Access Compliance Report

Public Rights-of-Way

(Curb Ramps)

Intersection ID: 15389	Main Street: E_INDEPENDENCE_BV	Cross Street: WILSHIRE_PL	Location: NE
ADA ID: 36254E724197	Ramp Type: Perp	Initial Pass/Fail: Fail	Overall Compliance: No
		Severity Score: 25

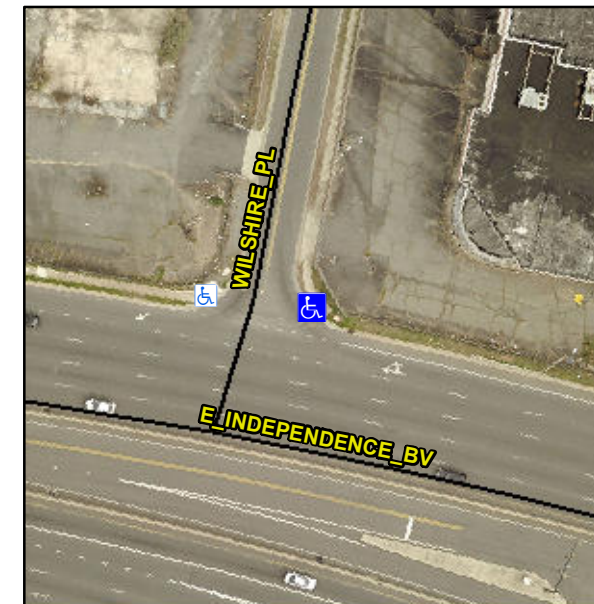
Not Found, R304.2.2, R304.5.3

Compliance	Description	Data	Compliance	Description	Data
N/A	Ramp Length (in)	88.0	No	Ramp Slope (%)	9.3
Yes	Ramp Width (in)	53.5	No	Ramp XSlope (%)	5.2
N/A	Flare Type LT	N/A	N/A	Flare Type RT	N/A
N/A	Flare Slope LT (%)	N/A	N/A	Flare Slope RT (%)	N/A
N/A	Flare Traversable LT?	N/A	N/A	Flare Traversable RT?	N/A
N/A	Landing Length (in)	N/A	N/A	DWS Provided?	N/A
N/A	Landing Width (in)	N/A	N/A	DWS Contrast?	N/A
N/A	Landing Slope (%)	N/A	N/A	DWS Length (in)	N/A
N/A	Landing X Slope (%)	N/A	N/A	DWS Full Width?	N/A
N/A	Landing Curb? (Y/N)	N/A	N/A	DWS Offset (in)	N/A
N/A	Shared Landing?	N/A			
N/A	Gutter Ponding?	N/A	N/A	Gutter Slope (%)	N/A
N/A	Gutter Lip Ht (in)	N/A	N/A	Gutter X Slope (%)	N/A
N/A	Painted X Walk1?	No	N/A	Painted X Walk2?	N/A
	X Walk 1 Direction	To NW		X Walk 2 Direction	N/A
N/A	X Walk 1 Width (in)	N/A	N/A	X Walk 2 Width (in)	N/A
	X Walk 1 Slope (%)	3.0		X Walk 2 Slope (%)	N/A
	X Walk 1 X Slope (%)	3.4		X Walk 2 X Slope (%)	N/A

Remove & Replace Entire Ramp.
